CITY OF NEWBURYPORT
HISTORICAL COMMISSION
60 PLEASANT STREET • P.O. BOX 550
NEWBURYPORT, MA 01950
(978) 465-4400
WWW.CITYOFNEWBURYPORT.COM

DOD Historical Report

Property Address 31-35 Market Square, Unit 1

Project description Replace existing ground floor (in restaurant area) windows with new windows within existing openings but with new configuration and operation.

Illustration 1: Excerpt from plan page A2.02, with differences highlighted.

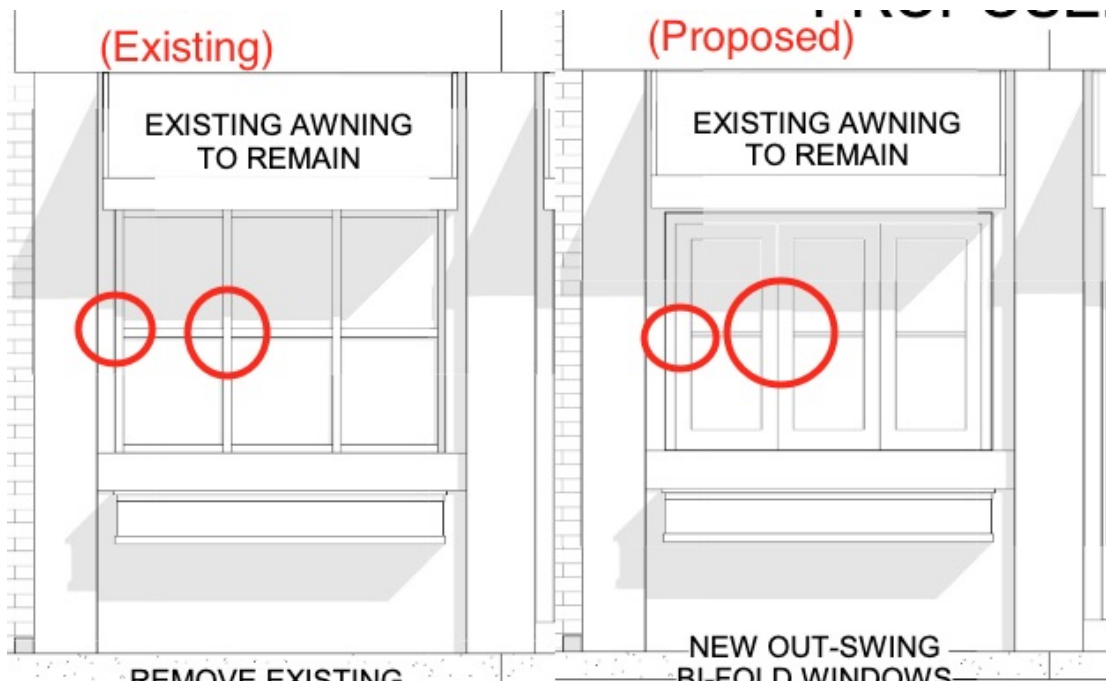
forms that adversely impact the character of the building, and by extension, Market Square. Our specific concern is that the stiles, rails and muntins dividing the lights will likely be uncharacteristically wide to an unacceptable degree.

The problem is this: the present configuration consists of groups of 9 or 12 lights (or panes) separated only by narrow muntins, each about 1.25" wide. But **operable** windows must be built as multiple separate units within the same overall window opening. Each individual, movable unit or sash will require vertical stiles on both sides, and horizontal rails top and bottom, to provide structural support. Stiles are wider than muntins, and where two stiles meet, this extra width is doubled. The result may be seen on the submitted plans, as revised 10 March, on page A2.02, which shows existing and proposed elevations. (See also *Illustration 1*.) The submitted "Muntin bar detail (3/10/20)" document indicates that the stiles are to be 3 inches wide, and muntins to be 1-15/16 inches (and too shallow or flat as well). A window with those specifications would have solid vertical elements over 6 inches wide where before there was only a muntin of about 1.25." We feel that this is not acceptable.

On the contrary, we would expect that any new windows shall have dimensions of the lights, stiles, rails and muntins that are similar to the current configuration, which in turn appears to be very similar to the configuration shown in the photograph on the Form B. We are highly skeptical that it is possible to build wooden framed windows that meet those requirements. It might be possible to achieve it by using metal as the framing material, since it is stronger than wood so it need not be so wide. The metal could also be given a profile and color such that it is very similar to a wood product in appearance, and therefore compatible with the Market Square environment. Chrome or stainless steel would be very inappropriate, but painted steel,

cast iron, etc. would be OK. (Although I expect cast iron would be prohibitively expensive.) In any event, the muntins should be about 1.25 inches, as they are now, or at most not more than 1.5 inches wide.
